SPEC. 19-13
EL DORADO LIFT STATION REPLACEMENT

Addendum No. 1
July 29, 2019

The following is Addendum No. 1 to SPEC. NO. 19-13 – EL DORADO LIFT STATION REPLACEMENT.

CONSTRUCTION SKETCH

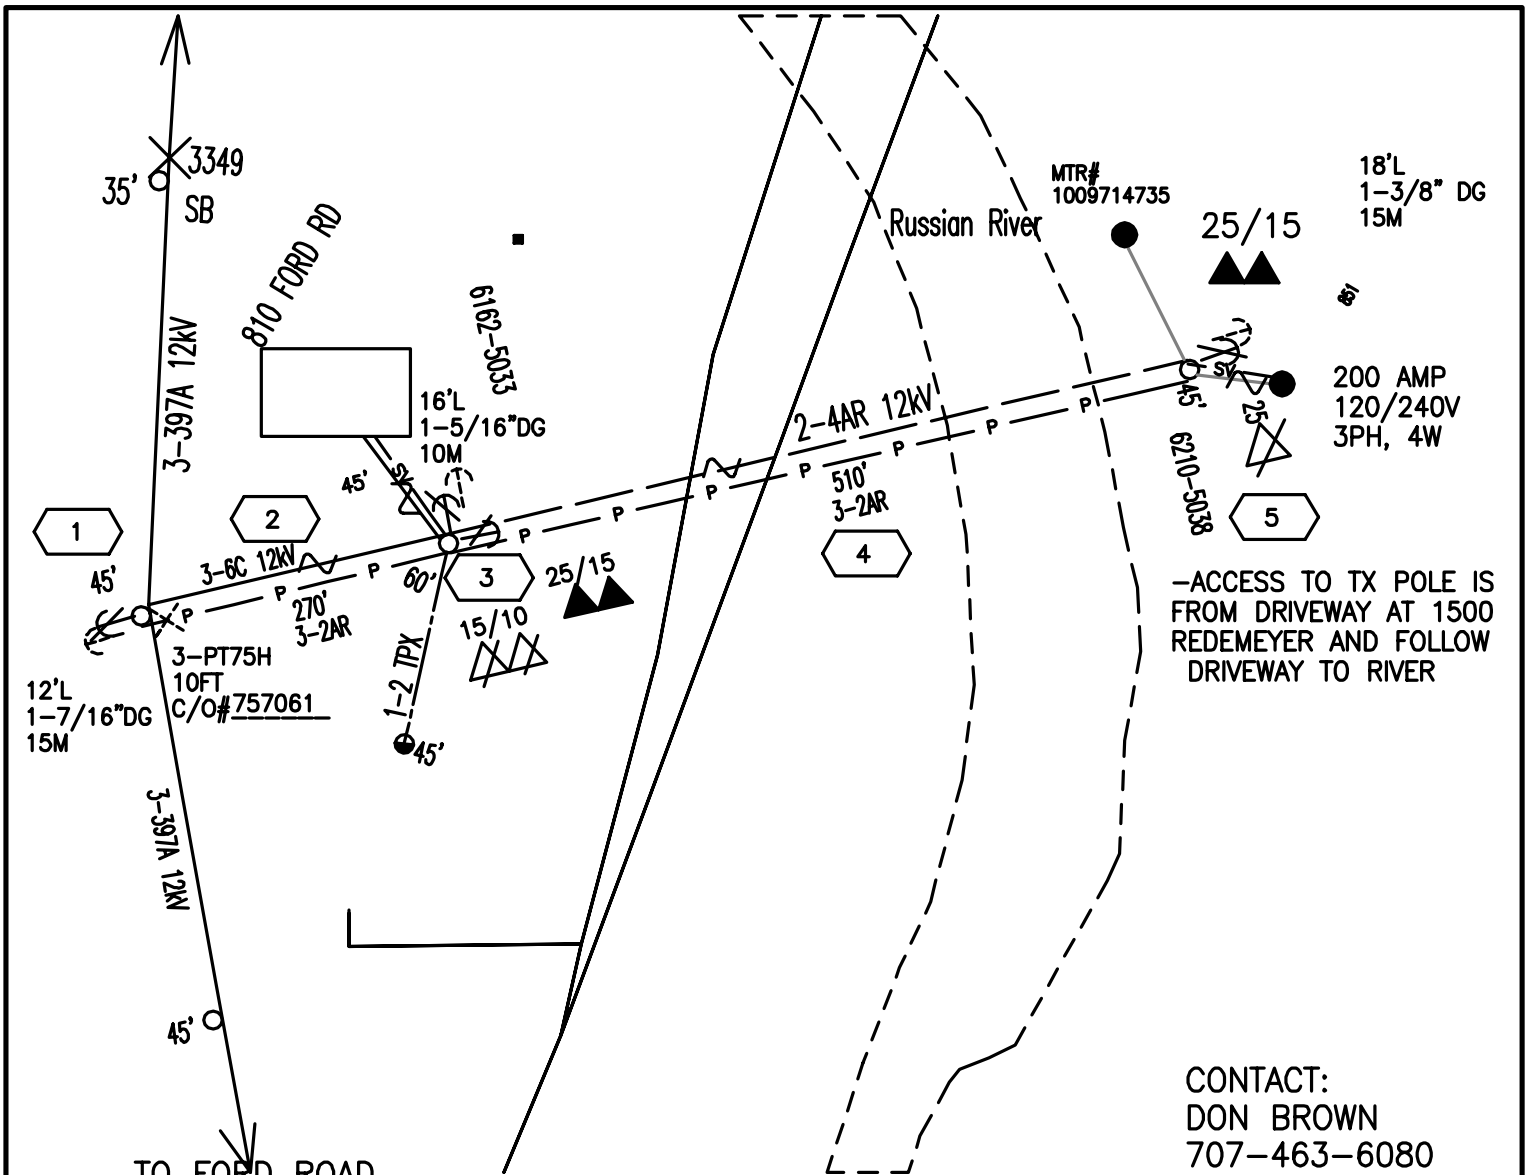
Q1: Can you provide the PG&E Engineering and installation schedule?

A1: Attached please find a PG&E provided construction sketch, as well as Spec 025055, from PG&E's Greenbook. The City is on PG&E's schedule for the work, but it is approximately 8-10 weeks out.
